# **Urgent Field Safety Notice**

**Subject:** Liko® Multirall™ 200 Q-link strap lock replacement

FSCA-identifier: MOD1322

Type of action: Device Modification

Correct vs incorrect attachment of Q-link strap lock of Multirall 200 to S65 rail carriage hook

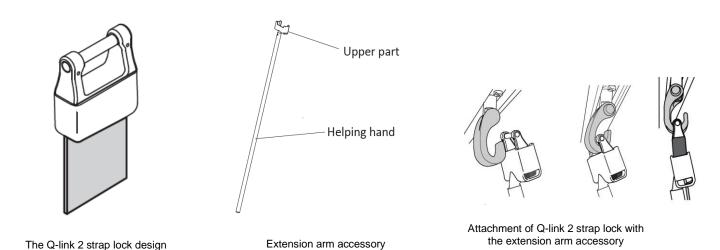
Hillrom continues to receive complaints of incidents where the Multirall Q-link strap lock has not been correctly attached to the \$65 rail carriage hook by user (illustrations below). This may lead to the Multirall lift becoming detached from the rail system, potentially resulting in the fall of both the lift motor and the patient. An advisory notice, with reinforcement of the instructions for use was shared with all customers of the Multirall 200 in 2017 (MOD1267), and since then additional complaints of serious incidents due to this use error have been received by Hillrom.

The Q-link II strap lock (illustration below) was introduced on the Multirall overhead lift to resolve ease of use issues with the application of the Q-link strap lock to the \$65 carriage hook, particularly while applying the Q-link strap lock from the ground level with the Extension Arm accessory (illustration below). The Q-link II has a larger opening which allows for better visibility while attaching the hook and the rolling feature of the Q-link II strap lock makes it easier to apply on the \$65 rail carriage hook.

Hillrom will be replacing the Q-link on Multiralls to Q-link II to improve ease of use and mitigate potential risk to patient or caregiver.

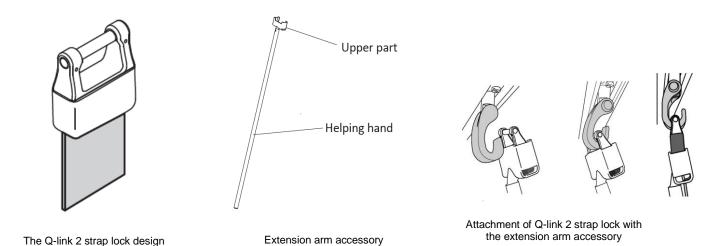
The Q-link II strap lock (illustration below) was introduced on the Multirall overhead lift to resolve ease of use issues with the application of the Q-link strap lock to the S65 carriage hook, particularly while applying the Q-link strap lock from the ground level with the Extension arm accessory (illustration below). The Q-link II has a larger opening which allows for better visibility while attaching

the hook and the rolling feature of the Q-link II strap lock makes it easier to apply on the S65 rail carriage hook.

Hillrom will be replacing the Q-link on Multiralls to Q-link II to improve ease of use and mitigate potential risk to patient or caregiver.
